Engineering/Process Change Notice

ECN/PCN No.: M1669

| ECN/PCN NO.; M1009 | | | | |
|---|---|--|------------------------------------|--|
| Product Description: RJ45 10/100 Base-T Jack with Magnetic Module | Abracon Part Number / Part Series: ARJ11D Series | □ Documentation only⋈ ECN□ EOL | ⊠ Series □ Part Number(s) | |

| ECN/PCN NO.; M1009 | | | | |
|---|---|--|------------------------------------|--|
| Before update | _ | | | |

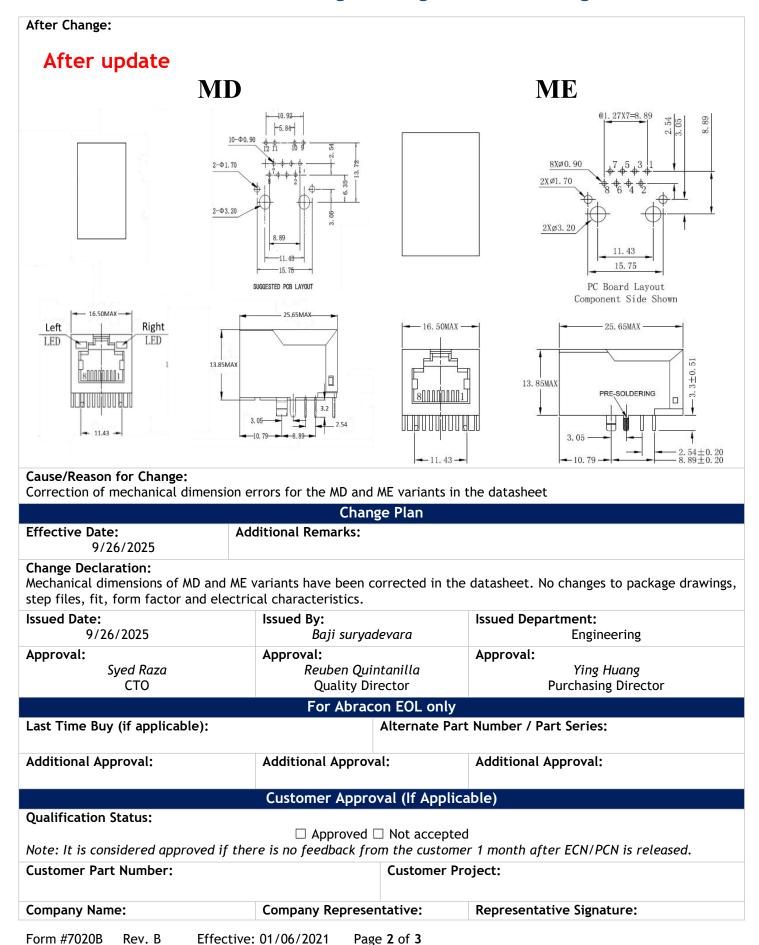
| ECN/PCN NO.; M1009 | | | | |
|---|---|--|------------------------------------|--|
| Prior to Change: Mechanical dimensions for the MD and ME variants were incorrectly specified in the datasheet. Refere update | | | | |
